20 February 2023

**FIELD SAFETY NOTICE**  
**for Distribution Partners of**  
**the HAMILTON-C6 Ventilator**  
**PN: 160021**  
**Reference #: CER 101091**

**Malfunction 2:**

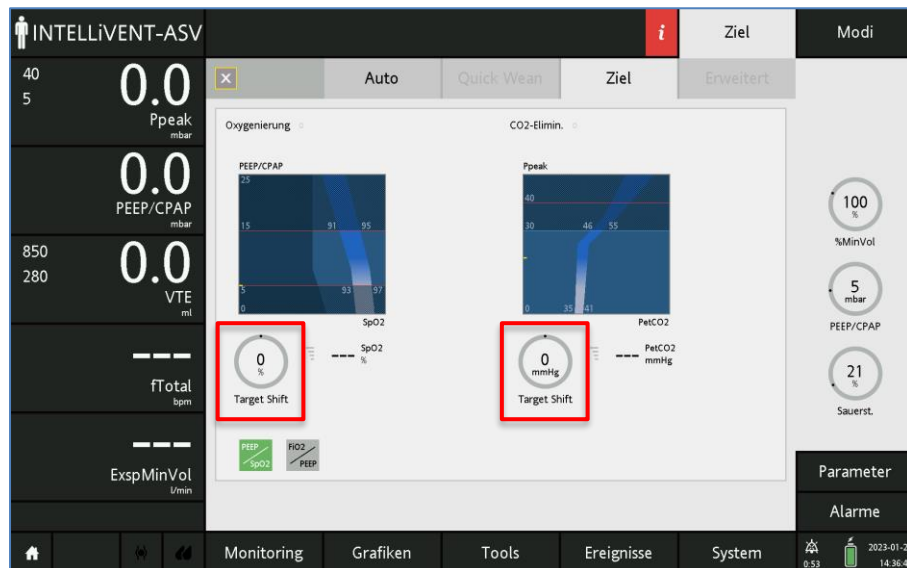
The display can be restarted by changing the Target Shift setting.

Software version affected: 1.2.1 and 1.2.2 with INTELLiVENT-ASV option installed.

**Further information:** The HAMILTON-C6 ventilator screen has restarted in some cases. It takes approximately 45 seconds for the screen to restart. During the restart process, the screen is dark and the device sounds an alarm. Ventilation continues in the INTELLiVENT-ASV mode. Apart from these few instances, one case was reported in which this problem triggered the safety ventilation mode.

This type of malfunction can occur if a user tries to set the Target Shift setting in INTELLiVENT-ASV mode.

<b>How can the problem be avoided?</b>	Using only the Press & Turn (P&T) knob to alter the Target Shift setting further reduces the likelihood of this type of problem.
<b>How can the problem be detected on the device?</b>	If the screen restarts, it will not respond to any touch command for approximately 45 seconds. The screen goes dark and restarts.  If the screen restarts and the ventilator goes into safety ventilation mode, the problem is evident because safety ventilation has been triggered. "Safety ventilation" is displayed on the screen in this mode. Inform your local distribution partner accordingly.  See the relevant instructions in the Operator's Manual (Section 7.7 Safety ventilation): <ol style="list-style-type: none"><li>1. Monitor your patient.</li><li>2. Provide an alternative device for ventilation.</li><li>3. Have the ventilator serviced.</li></ol>

A software update to software version 1.2.3 must be performed on ventilators with INTELLiVENT-ASV.
